MARTIN COUNTY, FLORIDA DEVELOPMENT REVIEW STAFF REPORT

SUNSET MEADOW MINOR FINAL SITE PLAN

Applicant:	Curet Family Trust
Property Owner:	Curet Family Trust
Agent for the Applicant:	HJA Design Studio, LLC
County Project Coordinator:	Elizabeth (Liz) Nagal, AICP, Principal Planner
Growth Management Director:	Paul Schilling
Project Number:	S274-002
Record Number:	DEV202212003
Report Number:	2023_0421_S274-002_Staff_Report_Final
Application Received:	03/08/2023
Transmitted:	03/09/2023
Date of Report:	04/21/2022

Boundary Survey Redlines

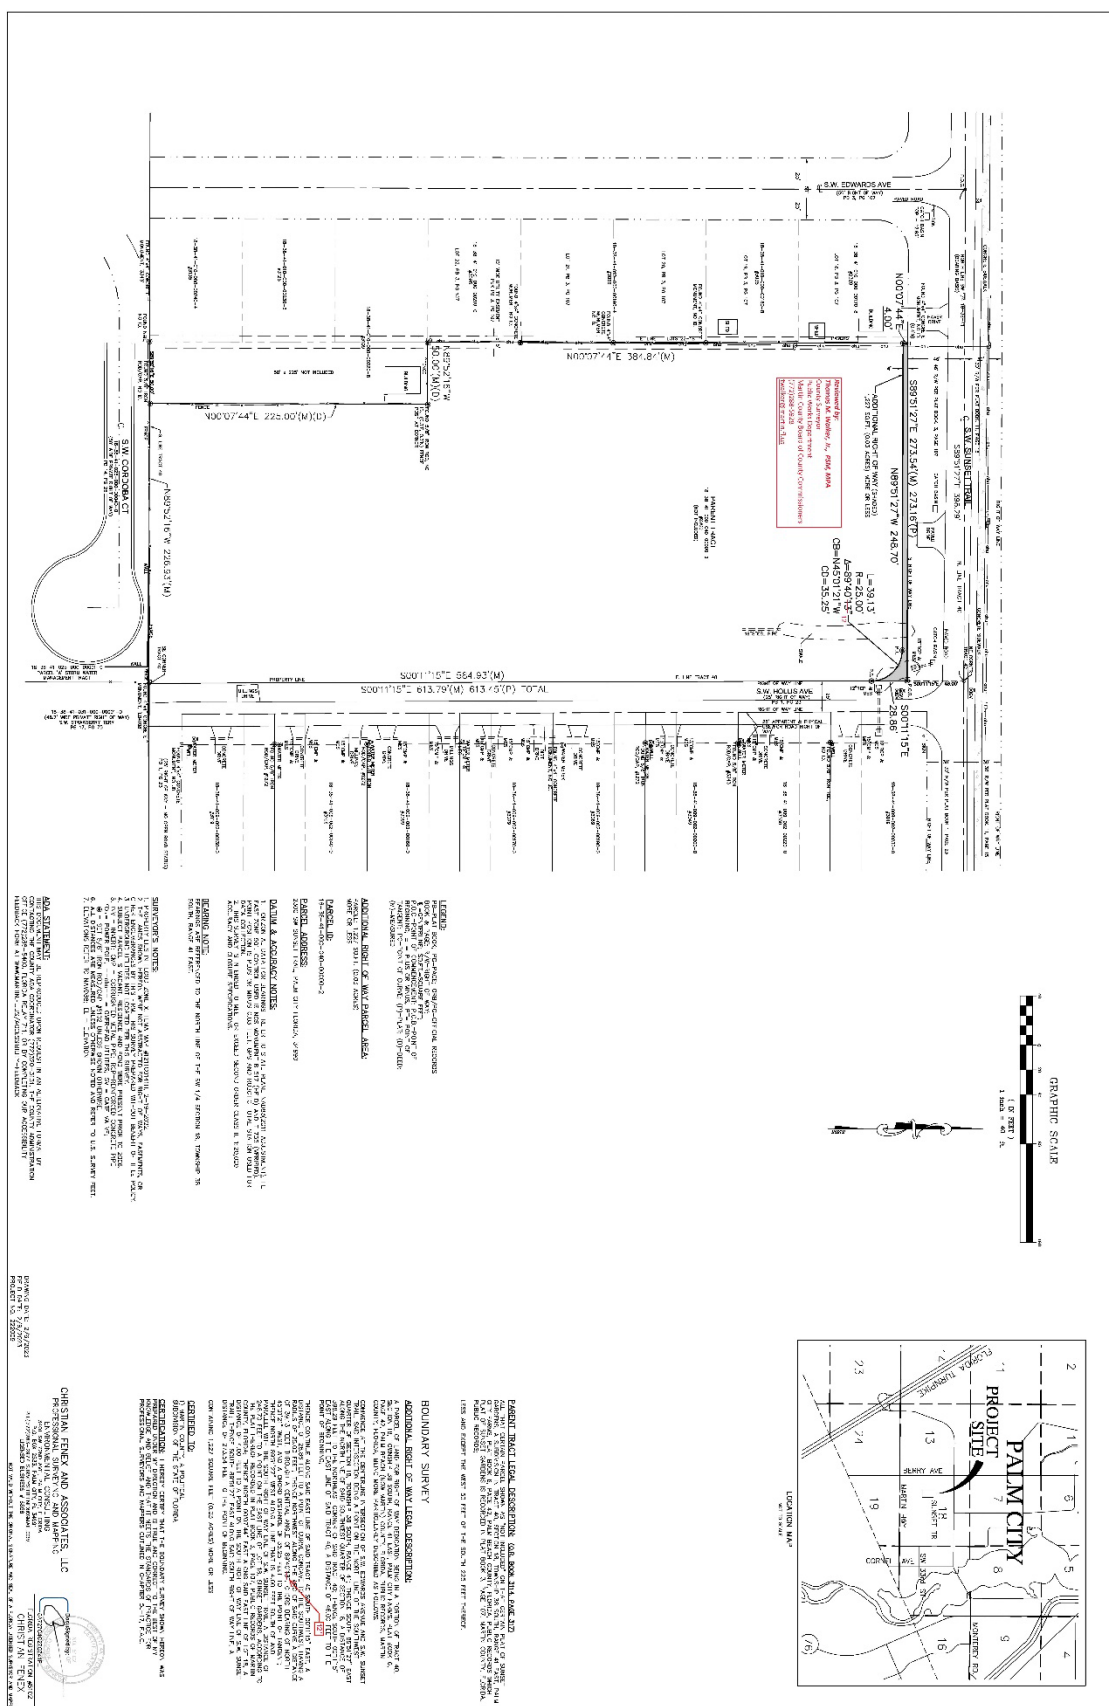
Note: The applicant did provide sketch and legal description (S&L) and an updated ROW boundary survey. The ROW boundary survey was not prepared with the benefit of the Title Commitment. Update the survey to include the Title Commitment information and revisions to both the Boundary Survey and the S&L as per the County's Surveying Division.
